Permit of Authorization to Construct an On-Site Sewage Facility Permit Valid For One Year From Date Issued

Permit Number: 118774

AEROBIC TREATMENT DRIP TUBING SYSTEM

RE: 149 Oak Summit Canyon Creek Estates 1 Lot 30

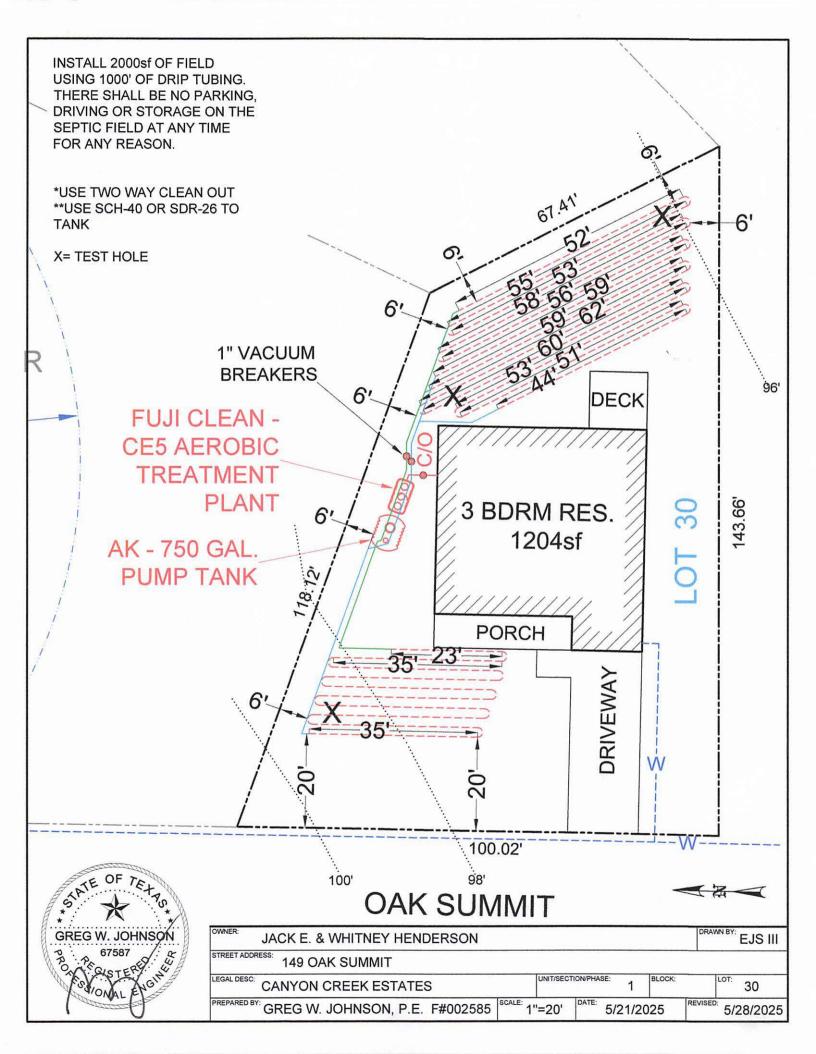
What is the well setback radius on the site plan? 100ft. or 150ft.?

THE WATER WELL IS 100' AND DOESN'T COME CLOSE TO THE PROPERTY IN QUESTION.
